SERVICE – BULLETIN

Reference-N°: KE-RT-2105 – v3.1

RT270-2 RT280-2 / Kick Down Switch Removal

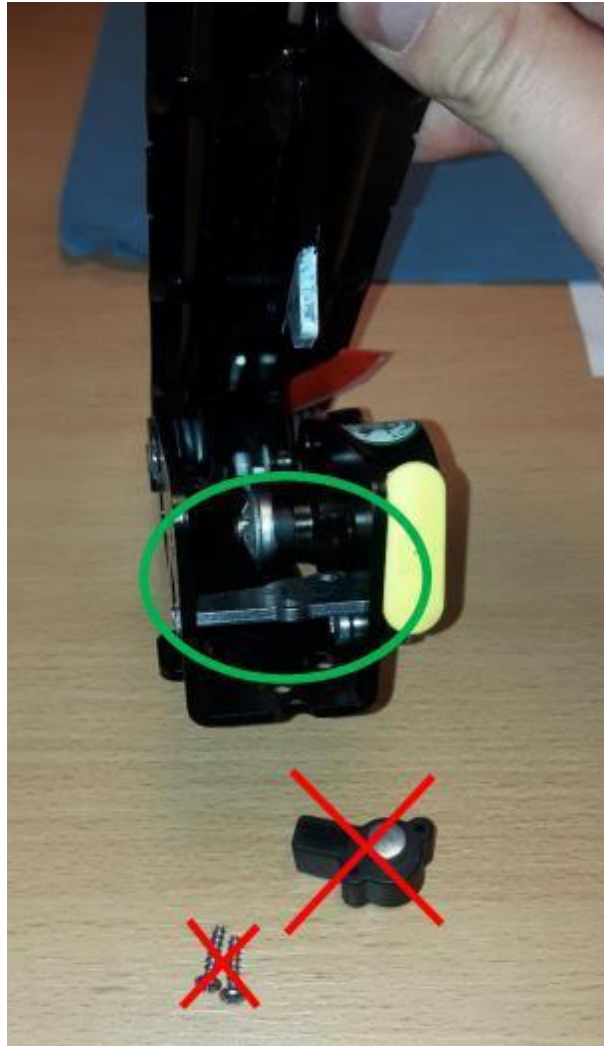
This safety bulletin is concerning the kick-down switch on accelerator pedal.
There is a risk of stuck accelerator pedal caused by the kick down switch.

On rare cases, this can happen when you press the accelerator pedal to the maximum.
In this situation, the pedal will pass the kick down switch and can get stuck.

Please therefore carry out the instruction below on all machines that are equipped with this pedal PN W21CKT5077 (Supplier PN 3106382A).

1. Remove connector from accelerator pedal
2. Remove accelerator pedal from cabin/safety roof
3. Remove the kick-down switch as shown here below

4. Mount the accelerator pedal back in reverse order
5. After the adjustment, it is recommended to recalibrate the accelerator pedal according to instruction job card attached in appendix on this bulletin.
